Proceedings of the Madras Government, Public Works Department,
18th January 1867.

Proceedings of a Regimental Board assembled at Bellary, on the 14th November 1866, by order of Colonel H. C. Brewster, Commanding 76th Regiment, to inspect and report upon the efficiency of the New Rifle Ranges for the use of the Regiment.

Remarks on Rifle Range of Her Majesty's 76th Regiment.

Rifle Butts at Bellary.—

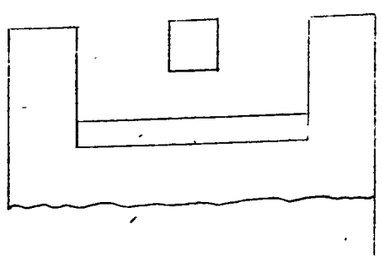
RICOCHET BUTTS.—The interiors are too deep to admit of the markers seeing sufficient ground down the Ranges, to detect Ricochets.

This may be rectified by rounding off the inner edges of the side walls, as shown in the diagram, in dotted lines.

This Butt is built at the exact angle laid down in the Standard Plan, if consequently it does not answer the intended purpose the fault is not with the Department Public Works; the cost of re-constructing it as now desired would be Rupees 100.
